TITLE: Longs Peak Farm Conservation  
Development Sketch Plan

REQUEST: Sketch Plan Review of a Conservation  
Development of a 86.4-acre parcel into  
43 single-family residential lots and  
three outlots

STAFF CONTACTS: Michael Whitley, Planning  
Clint Jones, Engineering  
Doug Ryan, Health Department

FILE #: 15-S3313

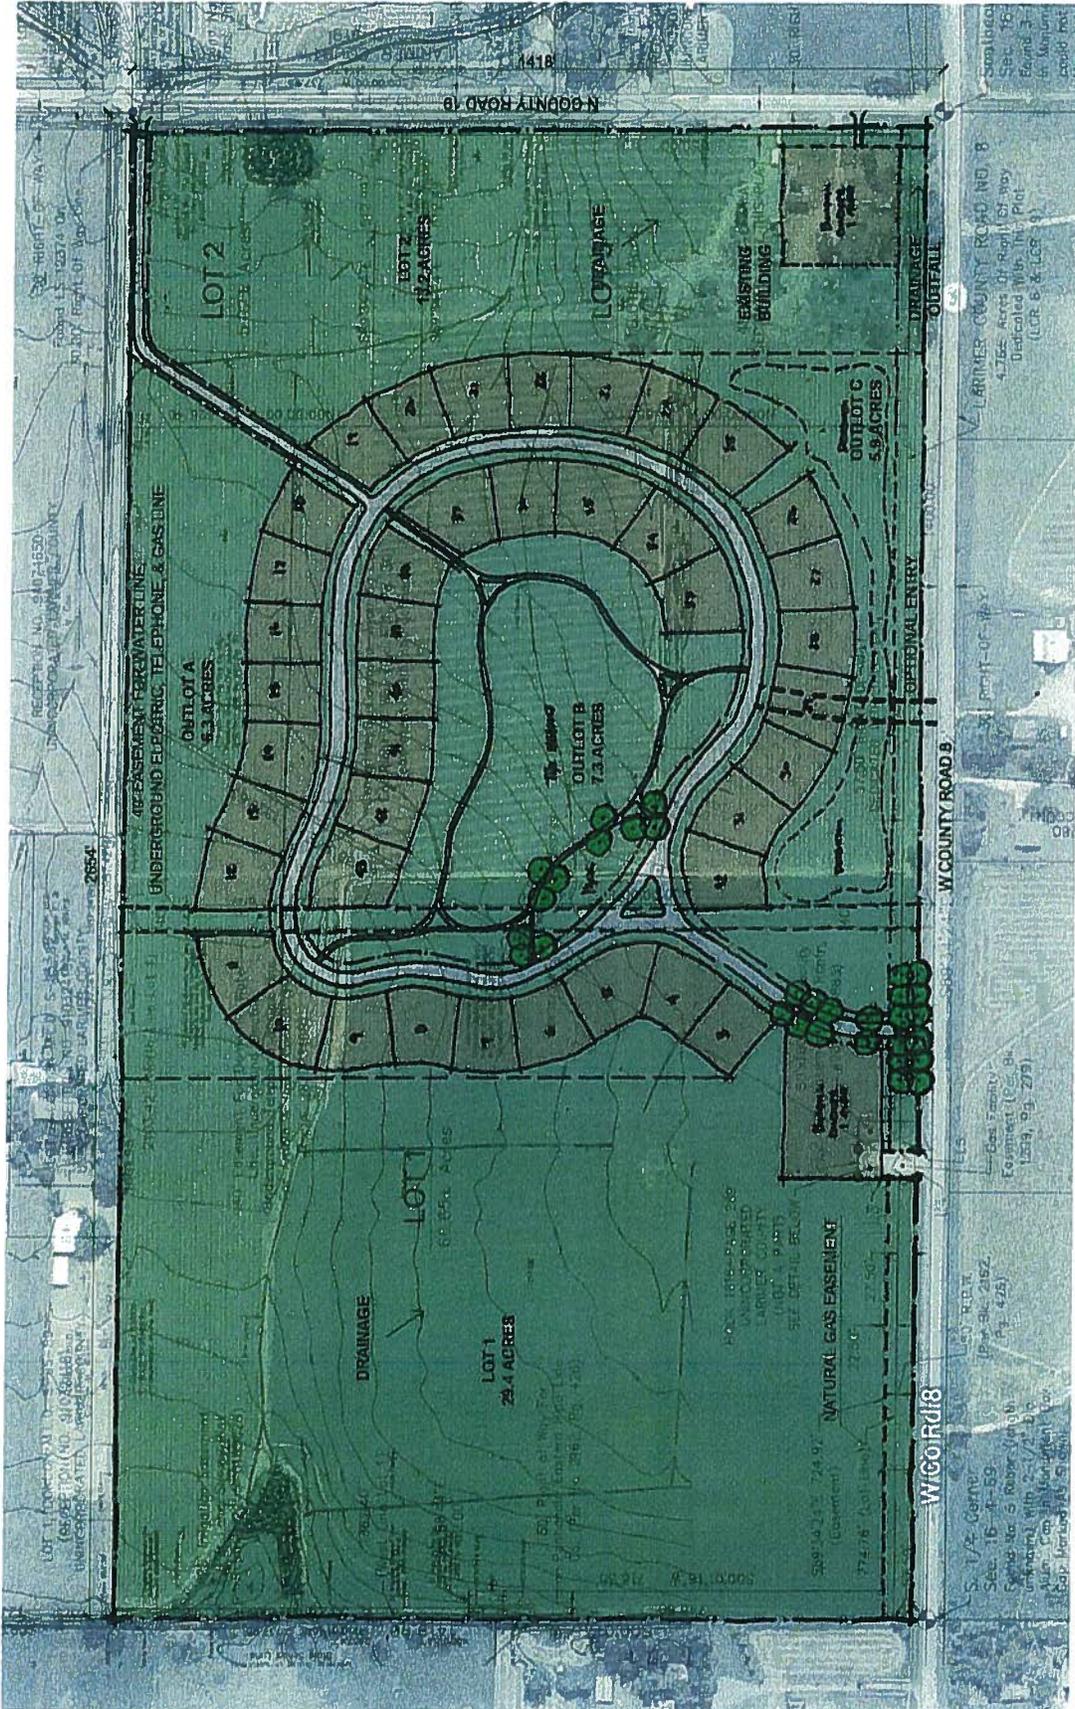
The applicant’s Sketch Plan exhibit does not identify residual land but it does identify two large lots (29.4 acres and 13.2 acres) with building envelopes and three outlots.

The Sketch Plan exhibit indicates that the homes on the two proposed building envelopes would gain direct access to W. County Road 8 and N. County Road 19. The remainder of the lots would gain access from new internal roads. The Sketch Plan shows a primary access to W. County Road 8 and a paved emergency only access onto County Road 19.

The Sketch Plan exhibit does not identify any residual land but contains Lot 1 which is a 29.4 acre parcel with a one-acre building envelope, Lot 2 which is a 13.2 acre parcel with a one-acre building envelope and three outlots totaling 19.5 acres.

Multiple provisions within Section 5.3.6.A of the Land Use Code (Residual Land Design) require that residual land be as large and continuous as possible. The proposed layout with two lots and three outlots does not meet the intent of these provisions. Lots 1 and 2 and Outlot A should be combined into one residual parcel. One building envelope could be established on the residual lot for the existing residence and outbuildings.

It appears to make sense to leave Outlots B and C as separate residual parcels as they serve specific recreational and detention purposes and will likely be maintained by the Homeowners Association.

Subtracting the building envelopes and assuming that the area within Lots 1 and 2 and the outlots can be reconfigured as residual land, only 60.1 acres of land would be residual where a minimum of 69.12 acres is required.

Connectivity is required to the north to improve circulation as the parcels to the north are further divided and developed. The Development Services Team recommends that this be accomplished by connecting a road to the northern property line from the loop road and then having that road continue east to County Road 19.

2. Please confirm that the proposed access onto LCR 19 & 8 meets the access spacing requirements of Table 10-1 of the LCRARS.
3. The Larimer County Engineering Department supports the emergency access onto County Road 19 in the general location shown. This access would need to be within a 51 foot right-of-way and be paved to the northern property line in order to provide connectivity. At the northern property line the access should be built as a temporary all weather surface road that would be relocated to the north if the property to the north were to develop. This would eventually allow the access to be relocated directly across from Berthoud Peak Drive rather than offset.
